CITY OF STOCKTON

LETTER OF CLARIFICATION NO. 2

MCKINLEY PARK RENOVATION PROJECT NO. WR21017

SCALE	AS SHOWN	APPROVED BY:	SHEET NO.
DESIGNED BY	JDK	DATE	CG201
DRAWN BY	PX		OF X SHTS
CHECKED BY	SKS	CITY ENGINEER	WR21017
RECORD DWGS.		STOCKTON, CALIFORNIA	PROJECT NO.

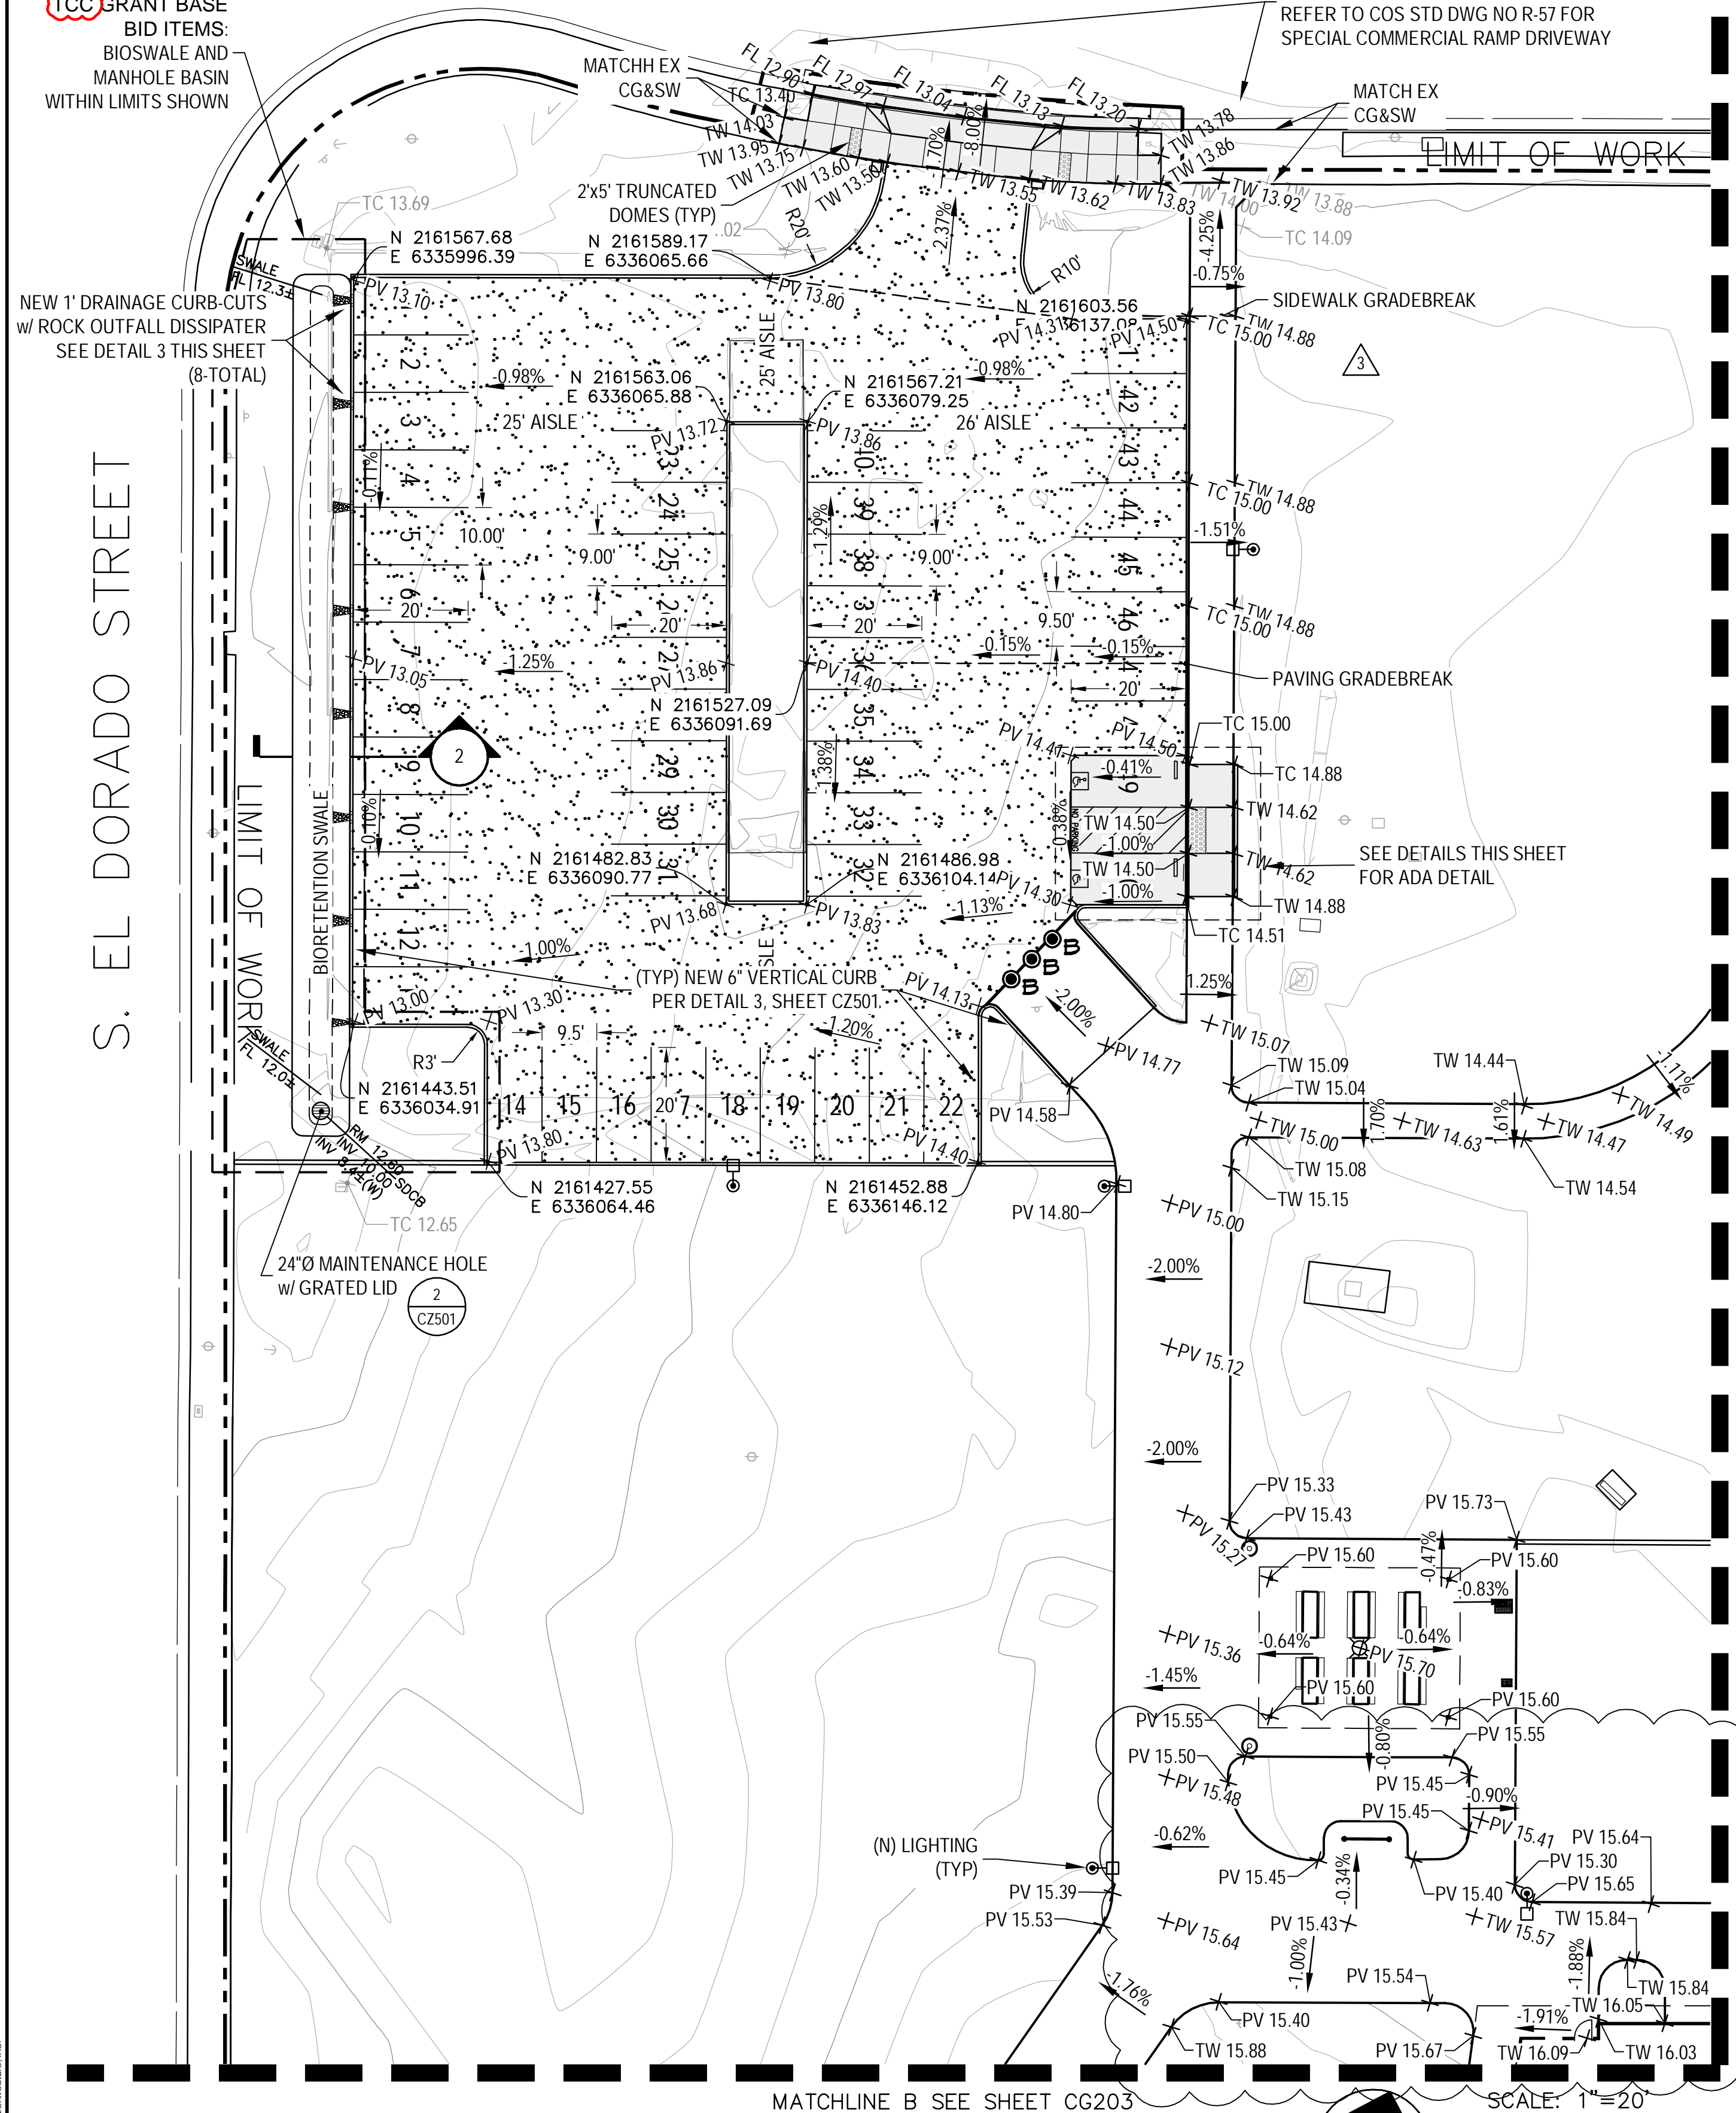
3. Sheet CG201 Grading Plan "Grant Base Note":
 - a. **ADD "TCC Grant Base"** to note label per attached revised sheet CG201
4. Sheet PL1.1 Planting Plan
 - a. **ADD Note "TCC GRANT BASE BID ITEM: INSTALL NEW TURF FROM SOD IN THE AREA SHOWN"** per attached revised sheet PL1.1.
5. Sheet IR 1.0 Detail 1
 - a. **ADD Detail 1**, refer to attached revised sheet IR1.0 which adds detail for wall mounted irrigation controller. Photo of existing Controller A installation provided for reference.
6. Sheet IR 1.0 Irrigation Legend "Gate Valve"
 - a. **REVISE** the legend note for Gate Valve description to read: **"GATE VALVE: SIZE PER LINE, NIBCO T-113K FOR SIZES UP TO 3", NIBCO P-619-RW FOR SIZES OVER 3"** per attached revised sheet IR1.0.

SHEET NO.
IR1.0
52 OF 156 SHTS
WR21017
PROJECT NO.

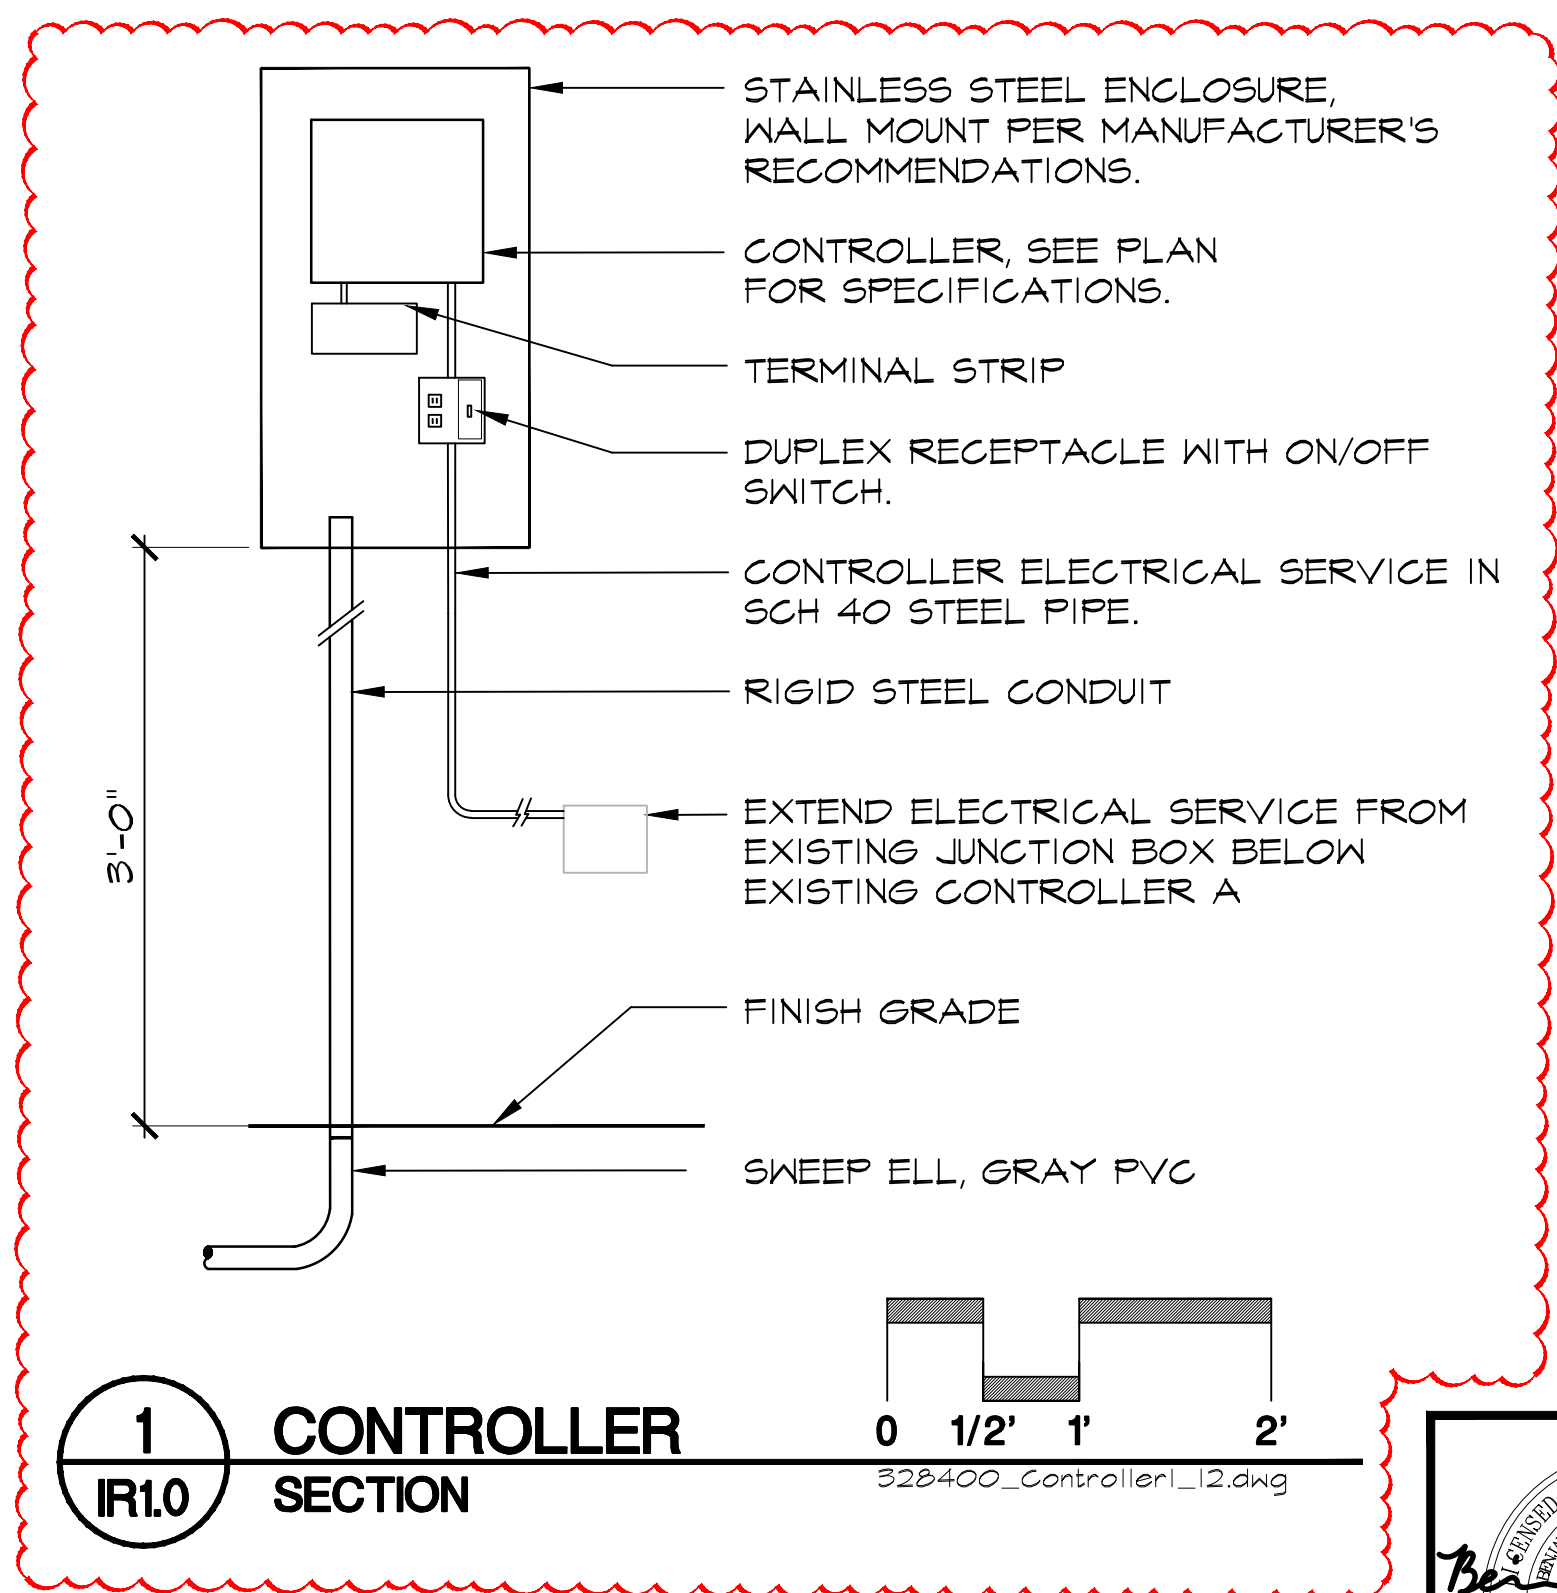
7. Sheet IR 1.0 Irrigation Legend

- a. **REVISE** the irrigation mainline description to read: **"IRRIGATION MAINLINE: PIPE SMALLER THAN 2" SHALL BE SCH 40 PVC, PIPES 2"-3" SHALL BE CLASS 315 SOLVENT WELD, PIPES OVER 3" SHALL BE CLASS 200 BELL AND GASKET"** per attached revised sheet IR1.0.
